**From:** Rich Glen [mailto:richglen@jt-engineering.com]
**Sent:** Wednesday, August 16, 2017 6:36 AM
**To:** Van Oudenhoven, Dawn - DOT <Dawn.VanOudenhoven@dot.wi.gov>
**Cc:** 'fradichel@charter.net' <fradichel@charter.net>; NE Local Program <NELP@jt-engineering.com>; Edwards, Brian - DOT <Brian.Edwards@dot.wi.gov>
**Subject:** 4854-03-00 CTH G Property owner request-ROW

**From:** Janke, Tom [mailto:Tom.Janke@fdlco.wi.gov]
**Sent:** Tuesday, August 15, 2017 1:07 PM
**To:** Peg Hawley <Peg.Hawley@omnni.com>; Ryan Gebhart <rjgebhart2000@gmail.com>
**Cc:** Sommer, Ryan <ryan.sommer@fdlco.wi.gov>
**Subject:** CTH G Property owner request

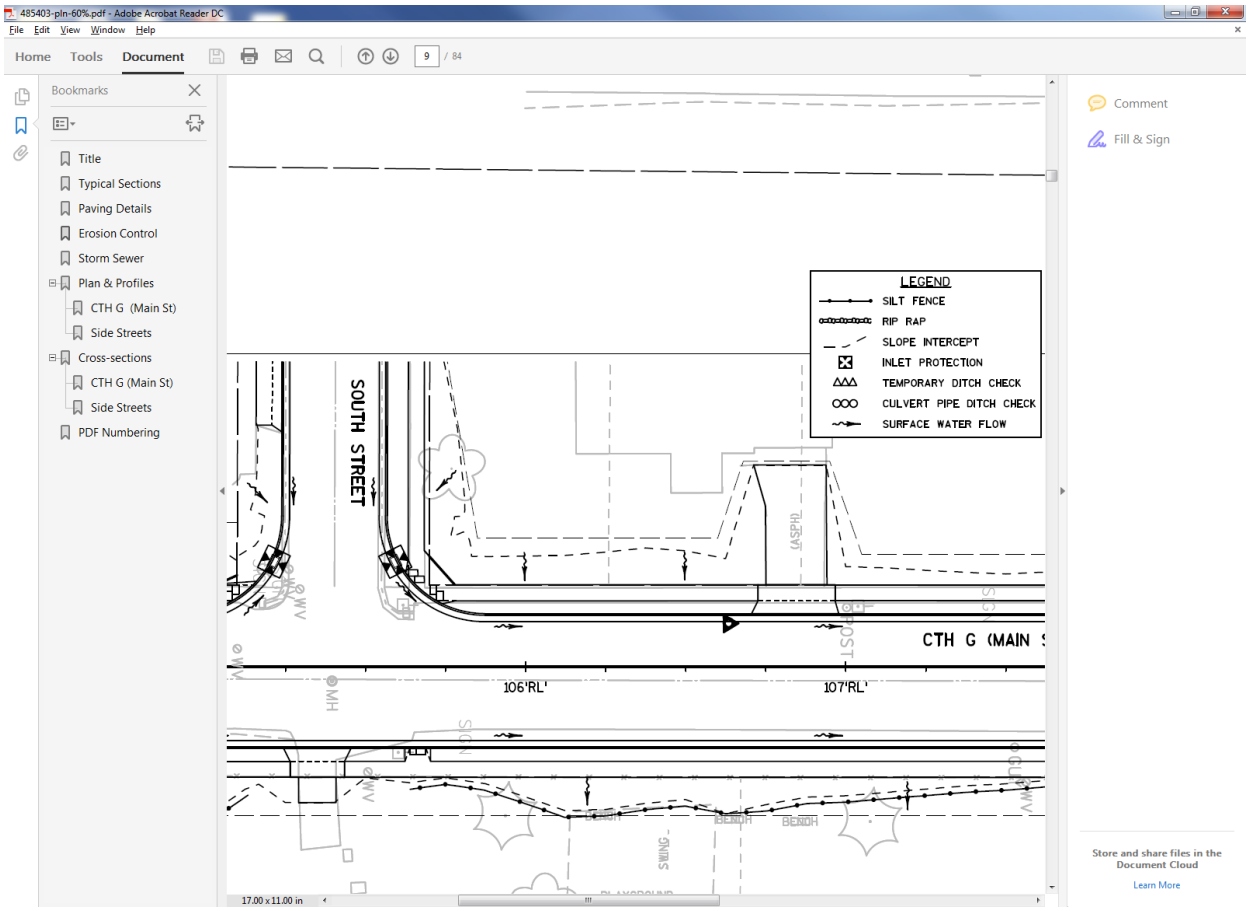
I received a call from a Lori Schueller at 900 Main Street shown below. She had the following concerns and requests. She was very adamant about her driveway being replaced up to the garage instead of leaving the 5 feet section in front of her garage door. She has an existing concrete driveway which was over laid with asphalt and seemed to prefer that it be replaced as a concrete driveway as well. Personally I don't have an issue with her requests if in fact we need to go up to that point I think replacing the whole section up to the garage makes sense.

Second she has a concern with her apple tree being removed on the south side. She inquired if that stretch of sidewalk could be eliminated as it ends at her property line to save the tree? I would look for the Village to respond if they would have an issue with that request otherwise could the sidewalk be shifted toward the road to save the tree or something else? She had other concerns with accessibility while construction occurs but I did state there should be accessibility most of the time but it may be on gravel or other surfaces and certain days where they are installing pavement or curb and gutter she would need to accommodate for setup and curing. Her number is 920-207-1124 and I stated I would inquire and get back to her otherwise Peggy you can contact her and let me know as well. Thanks Tom

This would be an acceptable reason to use a construction permit.

I would look to do option 2 and perhaps use the extra driveway replacement as a positive addition when negotiating the TLE from her. She also has requested a concrete driveway all the way. Thanks Tom

Driveway – I understand her concern about leaving a portion of the driveway. In general, I try to avoid having the roadway contractor work abutting any building if I can at all help it. Our grading does not require us to go all the way to the garage so we set our limits and TLE shy of the garage. I think we have the following options. Let me know which one you would like us to move forward with.

1. Change the Plat and show the TLE all the way to the garage
2. Leave the plat as is, get a right of entry and include the driveway all the way to the garage
3. Leave the plat and plans as is. Compensate her for the cost for the additional 5' and let her have her own agreement/contract with the contractor. Any discrepancy on grading next to the building as well as how the driveway ties into the stairs, entry door or garage door would be between the property owner and the contractor.

Apple tree – I think we would need WisDOT approval as well as the Villages to not put back pedestrian facilities. The tree is impacted by us needing to lower the profile to balance the matching of the fronts on both sides of the roadway more than replacing the existing sidewalk. Before we look at eliminating the sidewalk we will see if we can steepen the terrace (6:1) and maybe tweak the profile on South Street since it is a stop condition to try and save the tree.
